SUBJECT: **REVISION "A" TO ALERT SERVICE BULLETIN 206L-05-134:  
NEW TRANSIENT LIMIT AND POWER TURBINE RPM (N2) STEADY  
STATE OPERATION AVOIDANCE, INTRODUCTION OF.**

NO. 206L-05-134

**MODEL AFFECTED:** 206L3 and 206L4

### ENGINE, TURBINE ASSEMBLY - NEW THRESHOLD EVENT RECORDING AND NEW STEADY-STATE OPERATION AVOIDANCE RANGE LIMIT

Figure 1. Instrument panel

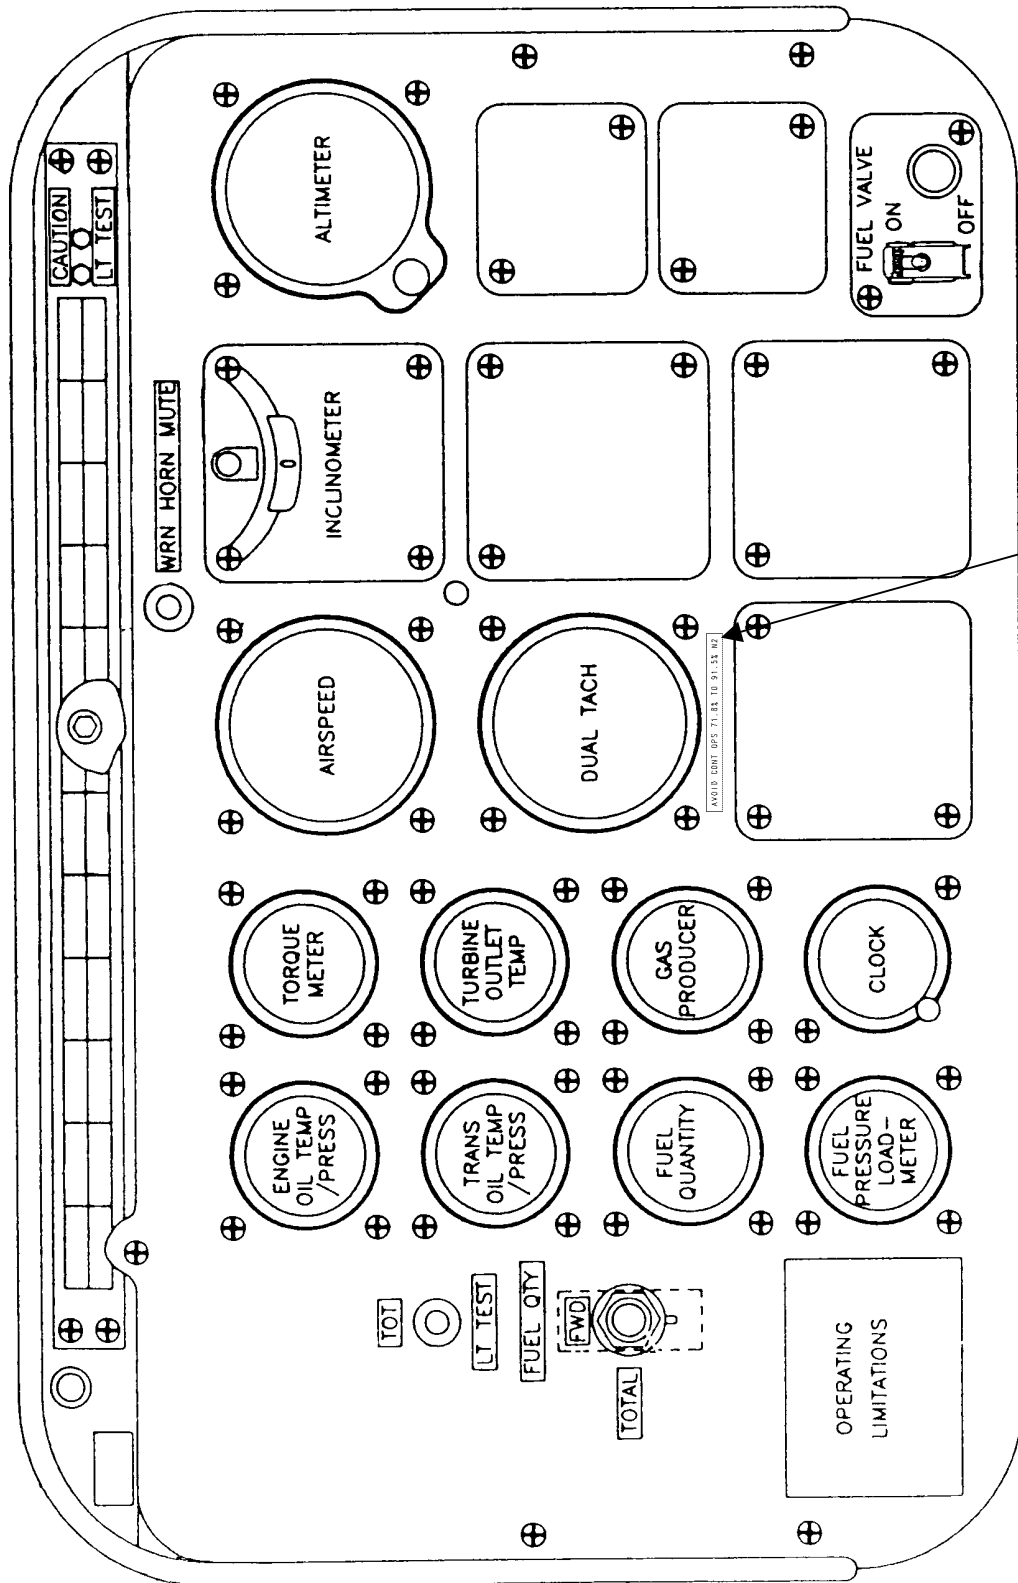
With the release of CEB A-72-3272, Rolls Royce revises the 250-C30P Engine Overspeed Limit Table introducing a new Steady State Operation Avoidance Power Turbine RPM (N2) Speed range between 71.8% and 91.5%. A decal is added on the instrument panel to ensure crew awareness of this new N2 speed restriction.

1. Install decal 230-075-213-117 on the instrument panel as shown in Figure 1. (Refer to applicable Maintenance Manual, Chapter 11).
2. Insert the new Flight Manual revision 6 dated April 26, 2005 into BHT-206L3-FM-1. (If applicable)
3. Insert the new Flight Manual revision 6 dated April 26, 2005 into BHT-206L4-FM-1. (If applicable)
4. Annotate the helicopter records indicating compliance with this bulletin.

Figure 2. Decal details

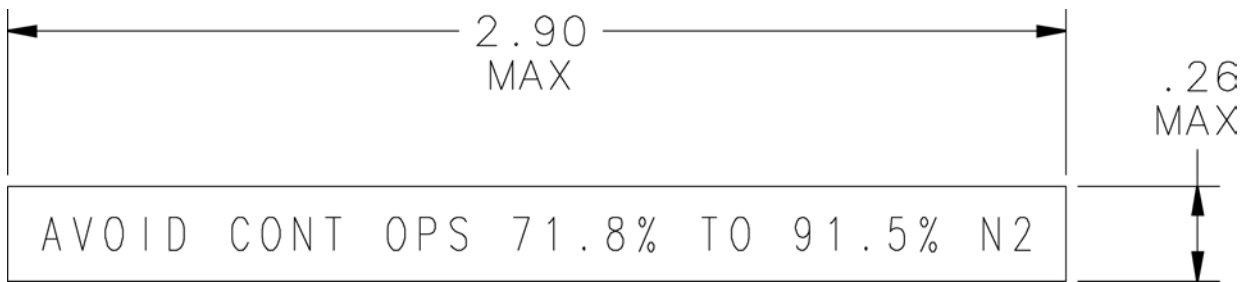
Note 1: The decal may be locally manufactured using lettering of white color No. 17875 on black background color No. 17038. Characters to be 10 point Spartan blackfont, color per FED 595. The text for on the decal is detailed in Figure 2 and should be in capital letters.

Power Turbine Speed Restrictions  
FIG. 1

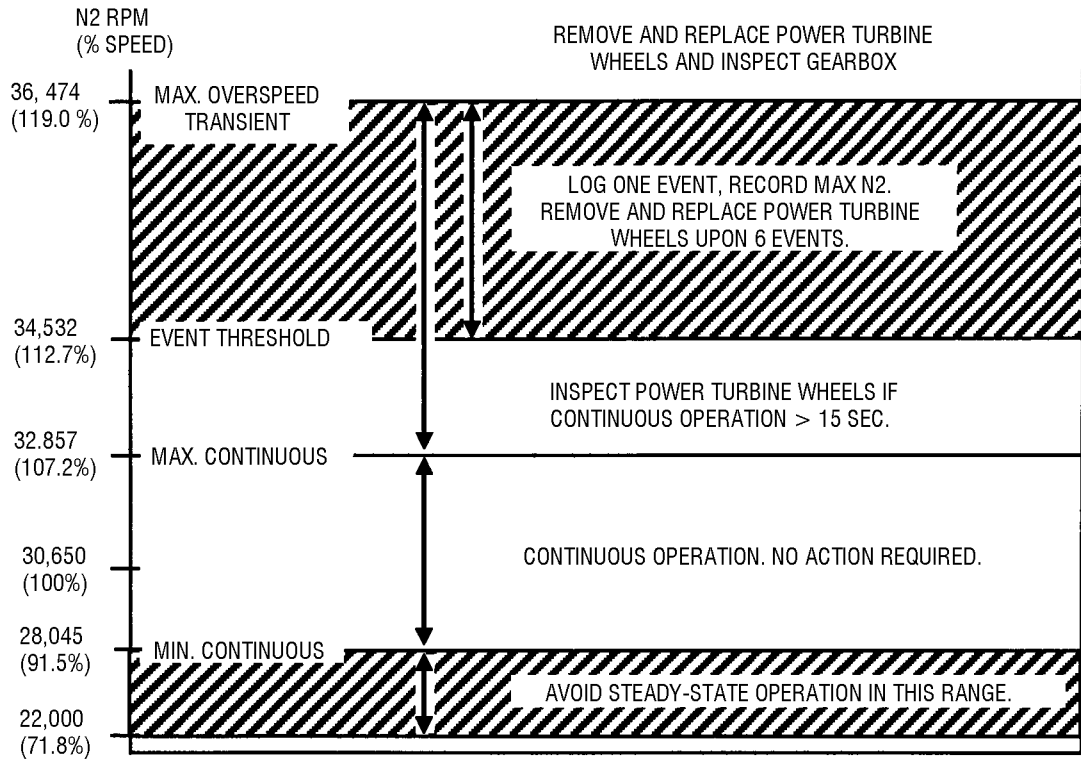
- (1) Transient overspeed excursions between the Max. Continuous line and the Max. Overspeed Transient line, which exceed 15 seconds require specific action as described in this CEB. Any excursion greater than 15 seconds requires power turbine wheel inspection.

- (2) The transient overspeed range is now divided into two sections. Any transient overspeed excursion above the Max. Continuous line and below the new Event Threshold line does not require maintenance action provided the single event is less than 15 seconds.

- (3) Any transient overspeed excursion above the new Event Threshold line and below the Max. Overspeed Transient line does not require maintenance action provided the single event is less than 15 seconds; however, the excursion shall be recorded as an event. No more than five events are allowed in this new range.

- (a) Maintain Engine Log Book Records so that transient N2 speed excursion events into the new range between 34,532 RPM (112.7% for the C30, C30G, C30M, C30P, C30R, C30R/1, C30R/3, C30R/3M, C30S, C30U and C47M; 112.4% for the C30G/2; 107.3% for the C47B; and 111.7% for the C40B) and 36,474 RPM (119.0% for the C30, C30G, C30M, C30P, C30R, C30R/1, C30R/3, C30R/3M, C30S, C30U, and C47M; 118.7% for the C30G/2; 113.3% for the C47B; and 118.0% for the C40B) are recorded. Record the maximum speed exceedance value and the date in the Life Limited Part Log Card.

- (b) Only five total events are allowed into this range. The sixth event into this range requires removal and replacement of the power turbine wheels.
